Access Compliance Report Public Rights-of-Way (Curb Ramps)

Intersection ID: 10005 Main Street: ROSLYN_AV Cross Street: S_GARDNER_AV Location: S

ADA ID: AC25991AD99A Ramp Type: Perp Initial Pass/Fail: Fail Overall Compliance: No Severity Score: 10

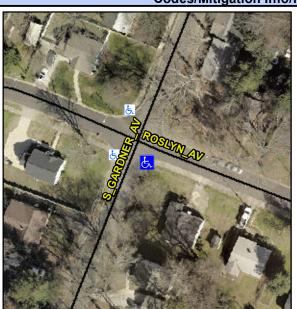
Not Found, R304.5.1, R304.5.3

Field Measurements/Component Compliance					
Compliance Description		Data	Comp	liance Description	Data
N/A	Ramp Length (in)	72.0	Yes	Ramp Slope (%)	6.0
No	Ramp Width (in)	47.0	No	Ramp XSlope (%)	2.3
N/A	Flare Type LT	N/A	N/A	Flare Type RT	N/A
N/A	Flare Slope LT (%)	N/A	N/A	Flare Slope RT (%)	N/A
N/A	Flare Traversable LT?	N/A	N/A	Flare Traversable RT?	N/A
N/A	Landing Length (in)	N/A	N/A	DWS Provided?	N/A
N/A	Landing Width (in)	N/A	N/A	DWS Contrast?	N/A
N/A	Landing Slope (%)	N/A	N/A	DWS Length (in)	N/A
N/A	Landing X Slope (%)	N/A	N/A	DWS Full Width?	N/A
N/A	Landing Curb? (Y/N)	N/A	N/A	DWS Offset (in)	N/A
N/A	Shared Landing?	N/A			
N/A	Gutter Ponding?	N/A	N/A	Gutter Slope (%)	N/A
N/A	Gutter Lip Ht (in)	N/A	N/A	Gutter X Slope (%)	N/A
N/A	Painted X Walk1?	No	N/A	Painted X Walk2?	N/A
	X Walk 1 Direction	To NW		X Walk 2 Direction	N/A
N/A	X Walk 1 Width (in)	N/A	N/A	X Walk 2 Width (in)	N/A
	X Walk 1 Slope (%)	3.1		X Walk 2 Slope (%)	N/A

Remove & Replace Entire Ramp.
